**ADDENDUM No. 6**  
**STREET DEPARTMENT GARAGE FACILITY - 2024**

**City of Oregon**  
**Department of Public Service**

**P1.1**

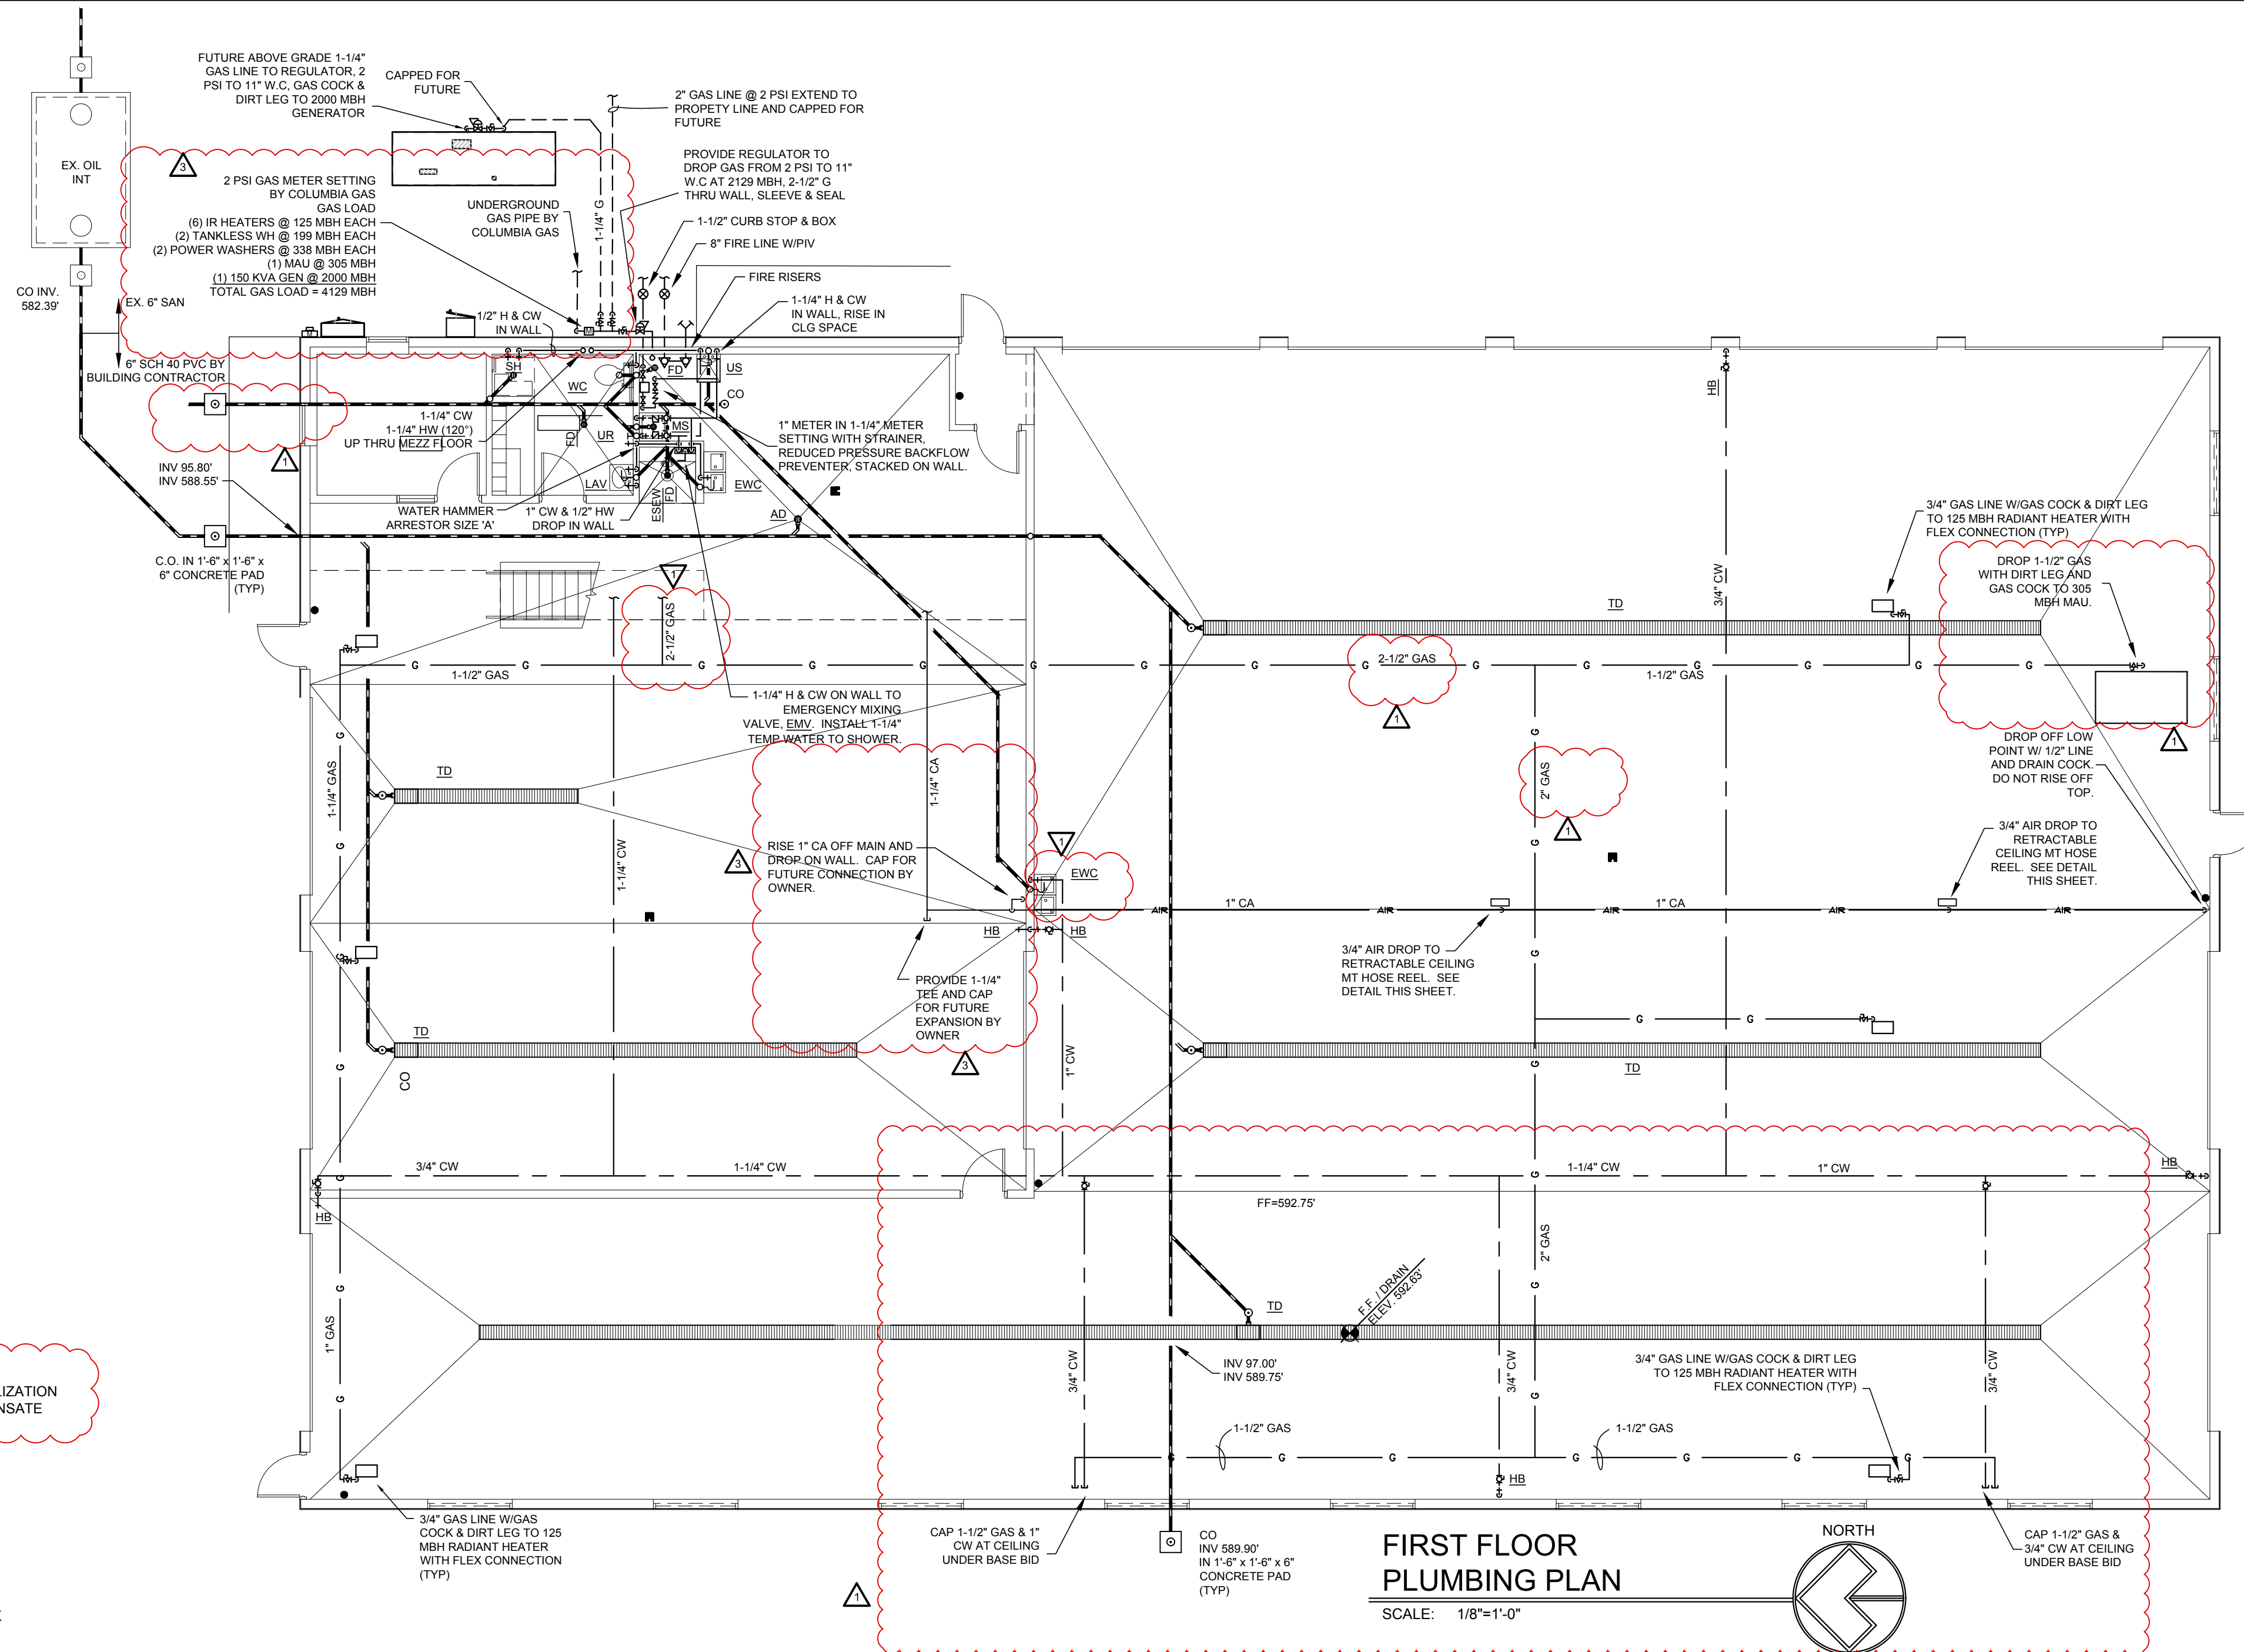
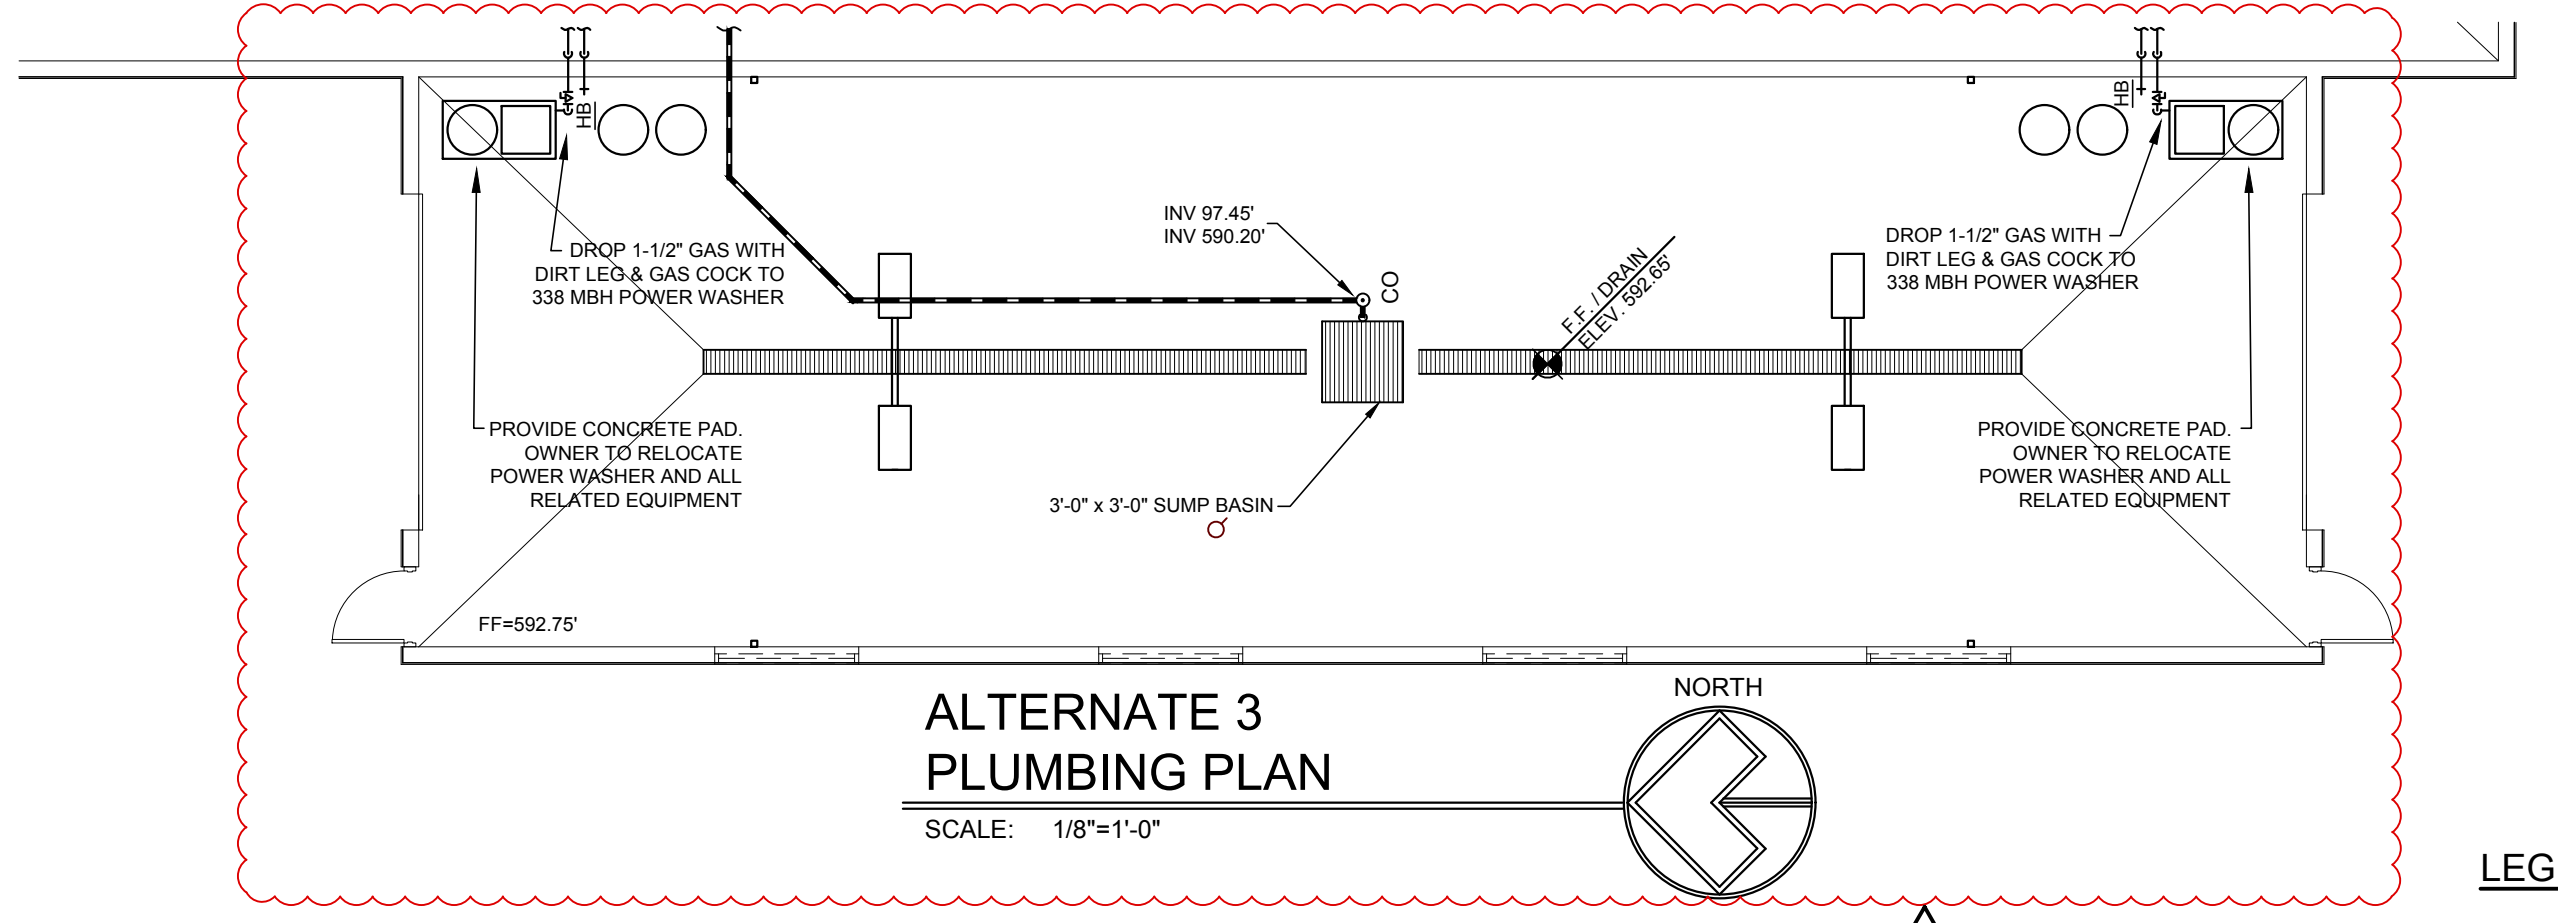
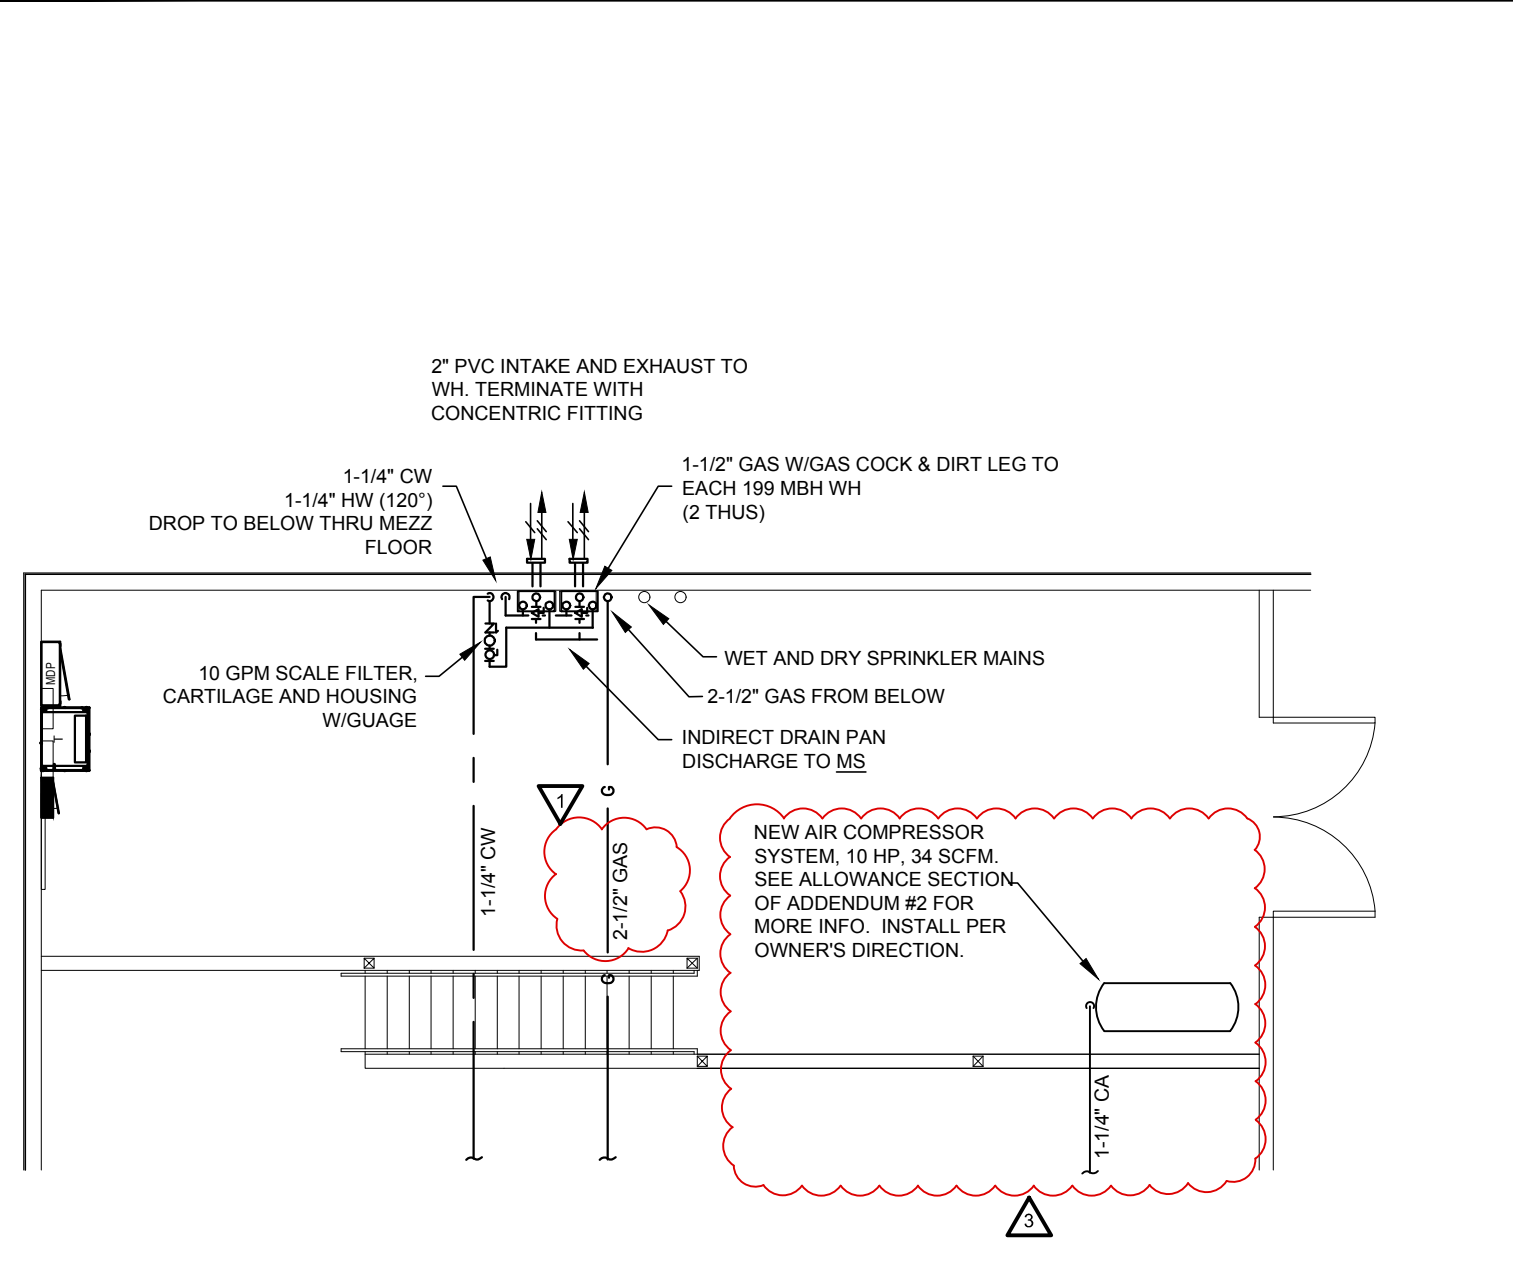
3) **Drawing P1.1 Tankless Water Heaters**

- Provide an appropriately sized neutralization tank for water heater condensate.

- 7) **Bidder Question:** *I see there is an allowance for a new air compressor. The one shown on the plumbing drawings says relocated. Assuming this will be a new air compressor and not an existing one we need to figure relocating and reinstalling? Also, will there be a piping detailed issued for the AC?*

**Architect/Engineer Response:** Columbia Gas to install underground service line and meter setting. Contractor is responsible for gas piping after the meter. See revised plumbing drawing P1.1 and C6.

**Architect/Engineer Response:** A new compressed air system shall be installed, no relocated air compressor. See revised plumbing drawing P1.1.
